Well Name: MERCILESS 13 FED COM
Well Location: T25S / R32E / SEC 13 / NWNE / 32.1370323 / -103.626757
County or Parish/State: LEA / NM

Notice of Intent

Procedure Description: EOG respectfully requests an amendment to our approved APD for this well to reflect the following changes: Update casing program to current design

Revised Permit Information 3/10/2021:

Revised Wellbore

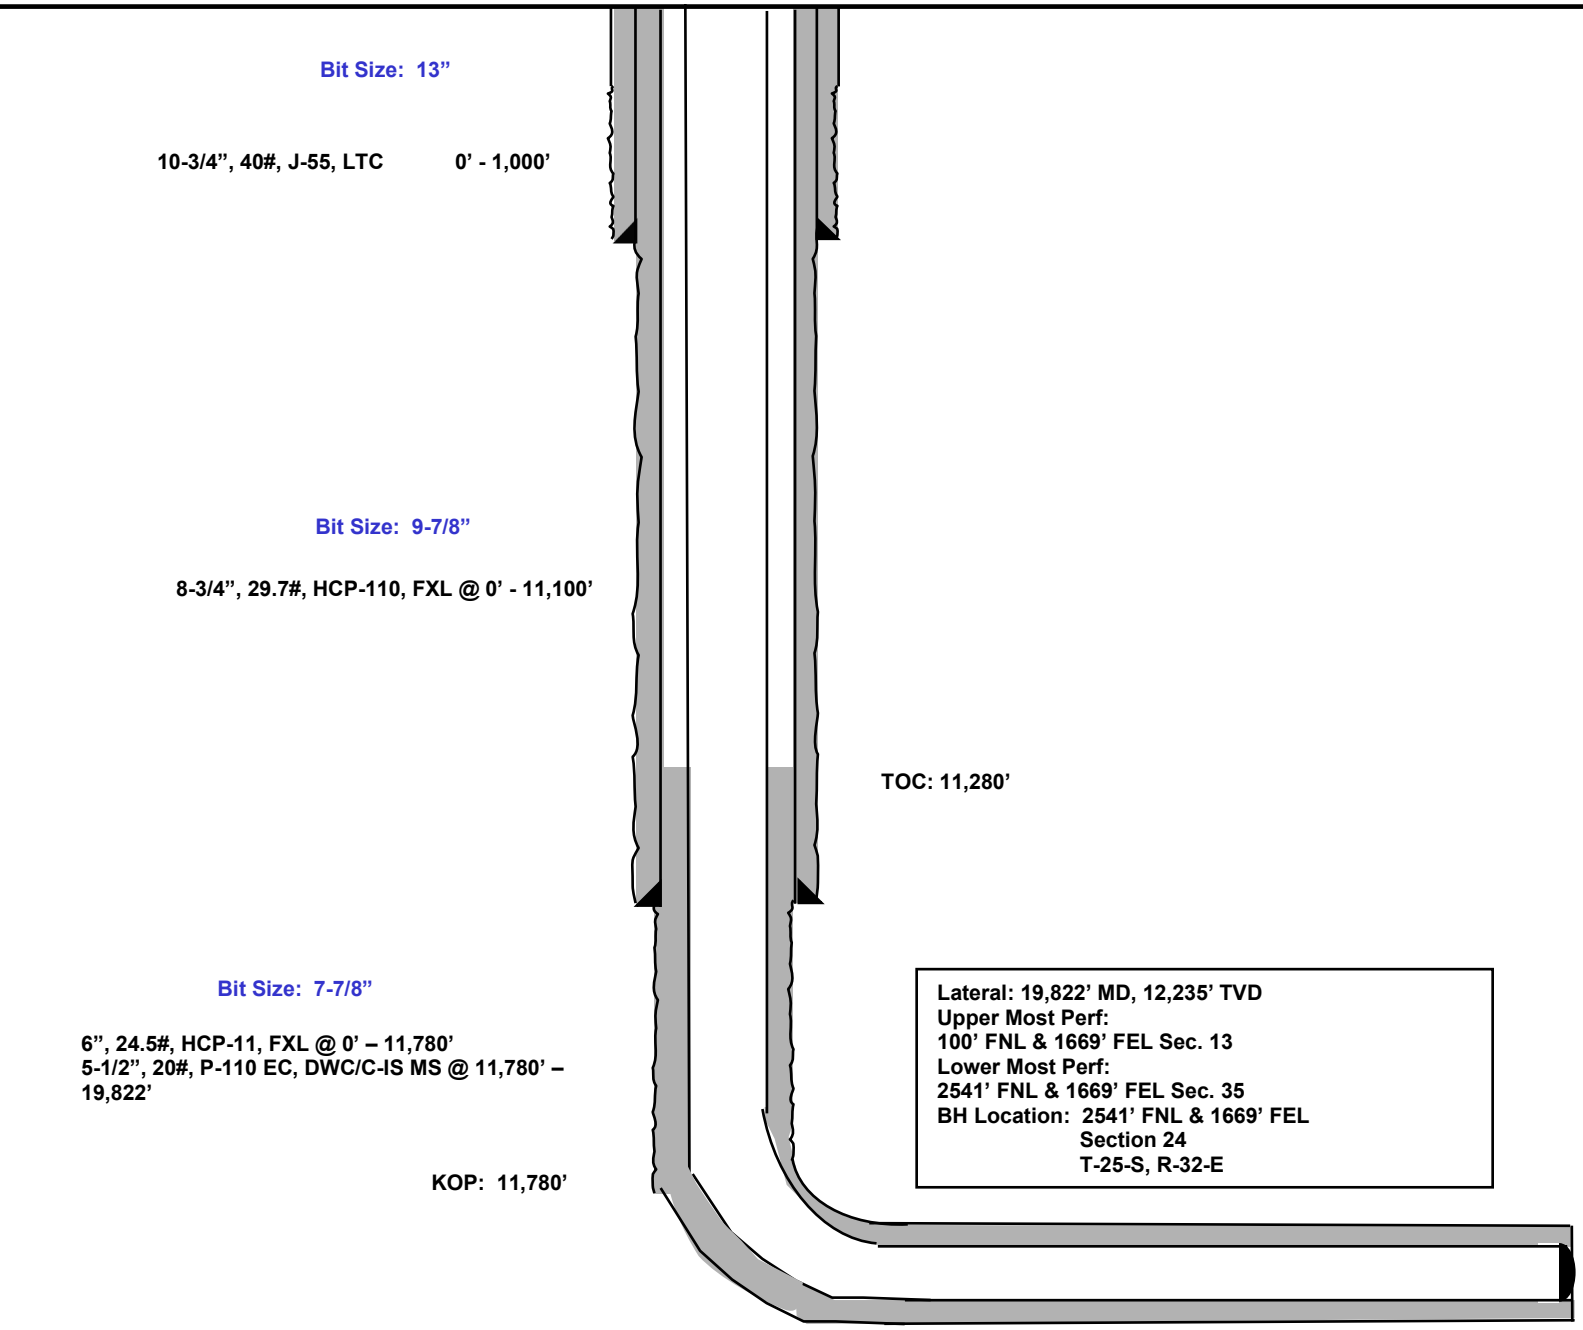
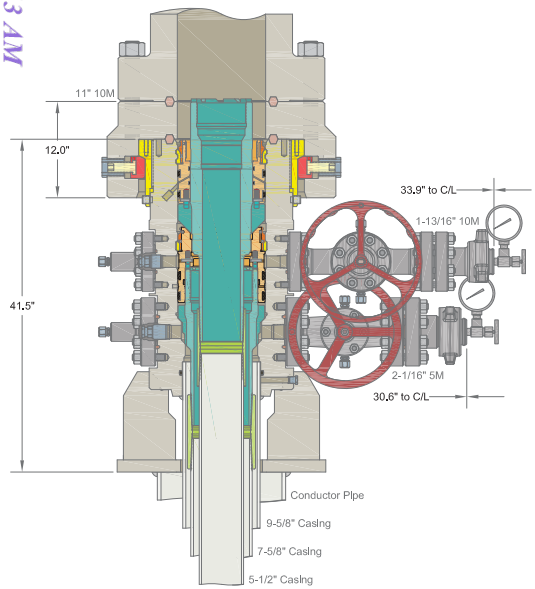
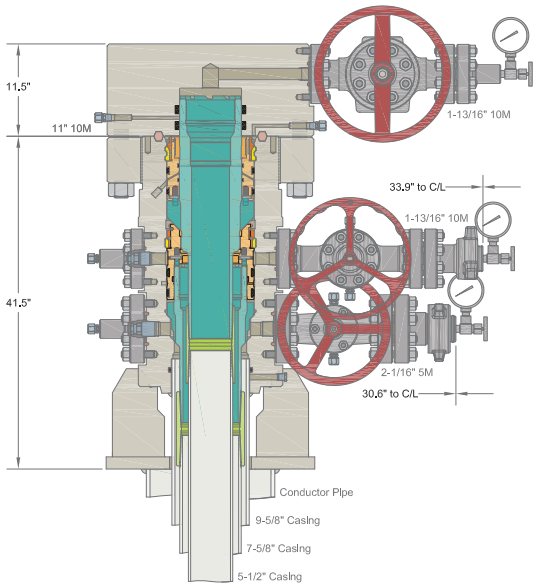
Hole Size	Interval	Csg OD	Weight	Grade	Conn	DF_{min} Collapse	DF_{min} Burst	DF_{min} Tension
13"	0' – 1,000'	10.75"	36#	J-55	LTC	1.125	1.25	1.60
9.875"	0' – 11,110'	8.75"	29.7#	HCP-110	FXL	1.125	1.25	1.60
7.875"	0' – 11,780'	6"	24.5#	P-110EC	VAM SFC	1.125	1.25	1.60
7.875"	11,780' – 19,822'	5.5"	20#	P-110EC	DWC/C-IS MS	1.125	1.25	1.60

Variance is requested to wave the centralizer requirements for the 8-3/4" casing in the 9-7/8" hole size. An expansion additive will be utilized, in the cement slurry, for the entire length of the 9-7/8" hole interval to maximize cement bond and zonal isolation.

Variance is also requested to wave any centralizer requirements for the 6" and 5-1/2" casing in the 7-7/8" hole size. An expansion additive will be utilized, in the cement slurry, for the entire length of the 7-7/8" hole interval to maximize cement bond and zonal isolation.
